THM 4T40-E

NEW PRESSURE REGULATOR VALVE AND SPACER PLATE FOR 2000

03-18 Page 1 of 4

Figure 1
AUTOMATIC TRANSMISSION SERVICE GROUP

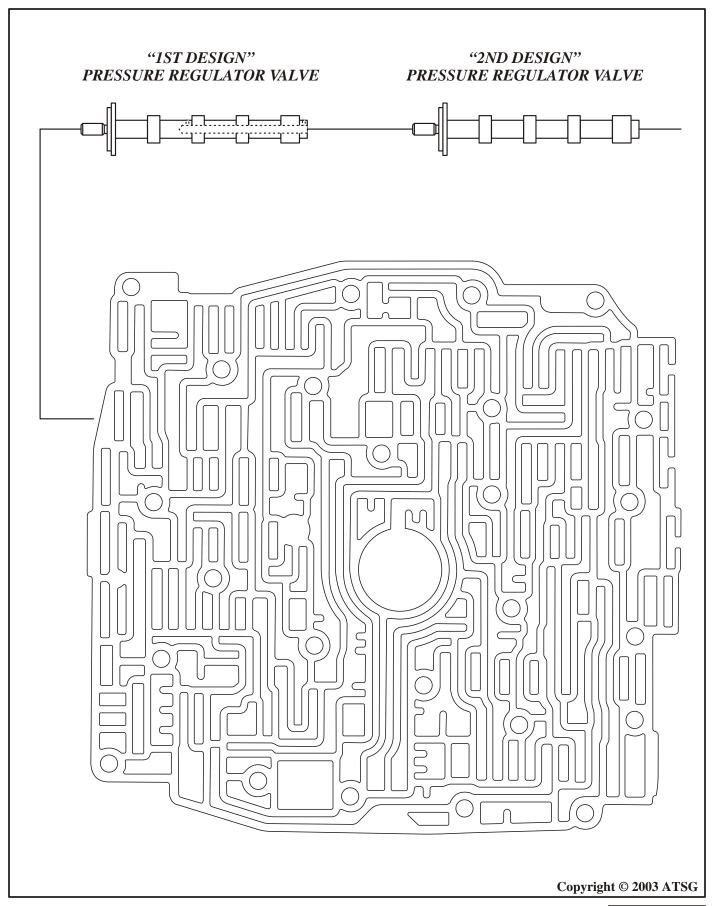
(1) PRESSURE REGULATOR VALVE - New design PR valve is not drilled through on the center line nor cross drilled, like the previous design PR valve, as shown in Figure 1.

Figure 2
AUTOMATIC TRANSMISSION SERVICE GROUP

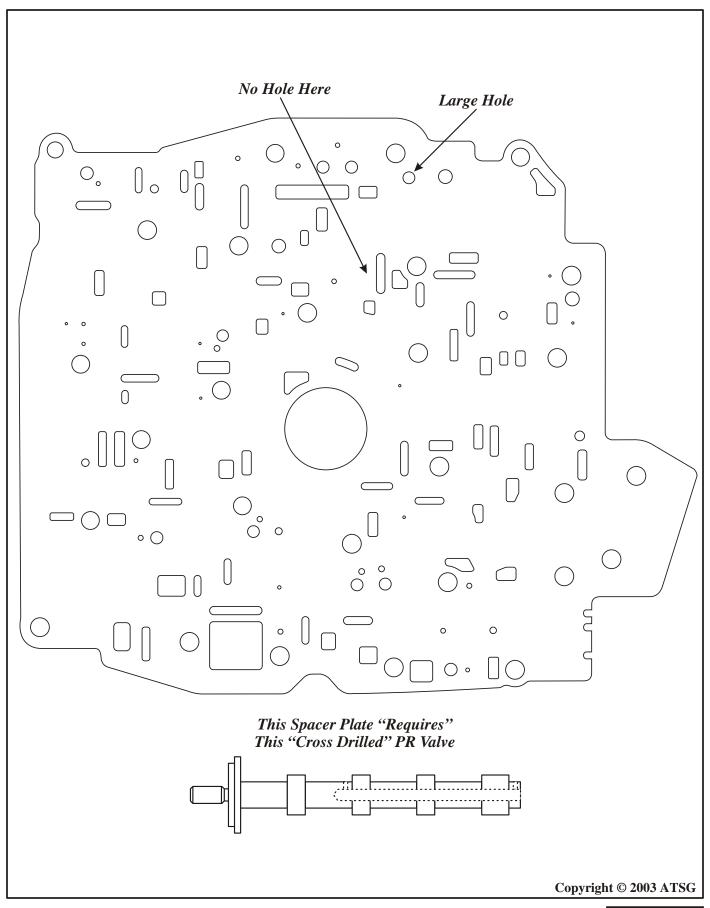
None of the parts listed above will interchange with any previous design level parts. However, when used together as a service package, they will retro-fit back to 1997 models. The 1st design "cross-drilled" PR valve *must* be used with the 1st design spacer plate, as shown in Figure 2.

Figure 3
AUTOMATIC TRANSMISSION SERVICE GROUP

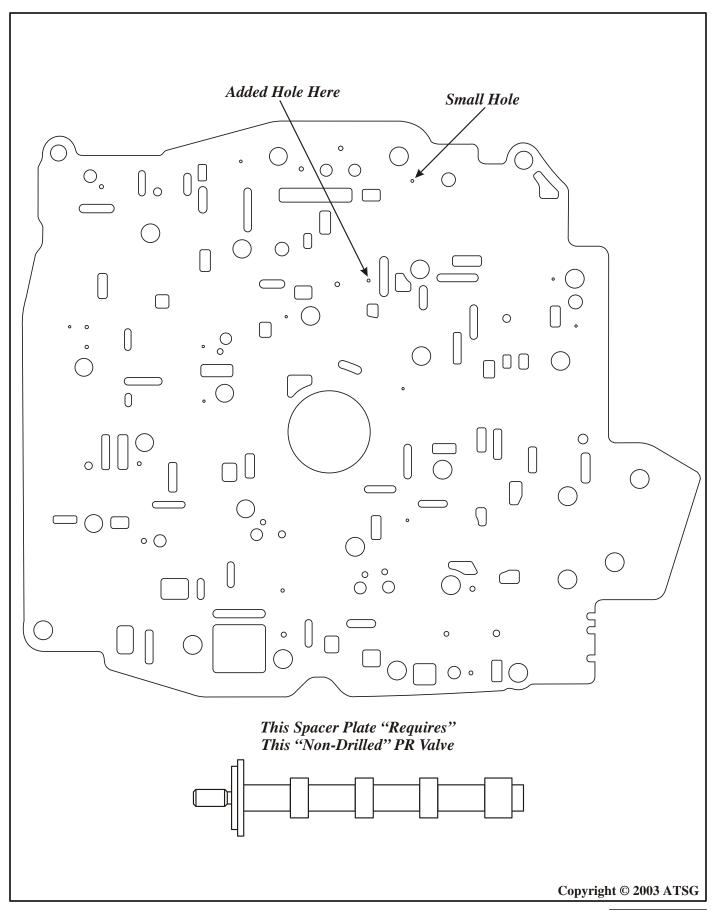
- (2) VALVE BODY SPACER PLATE New design spacer plate has one "Added" hole and one hole that has been made smaller, to redirect balance oil for the PR valve and accommodate the new design level, as shown in Figure 3.
- (3) VALVE BODY SPACER PLATE GASKETS New design spacer plate gaskets with an added hole to accommodate the new design spacer plate.

The 2nd design "Non-drilled" PR valve *must* be used with the 2nd design spacer plate, as shown in Figure 3.
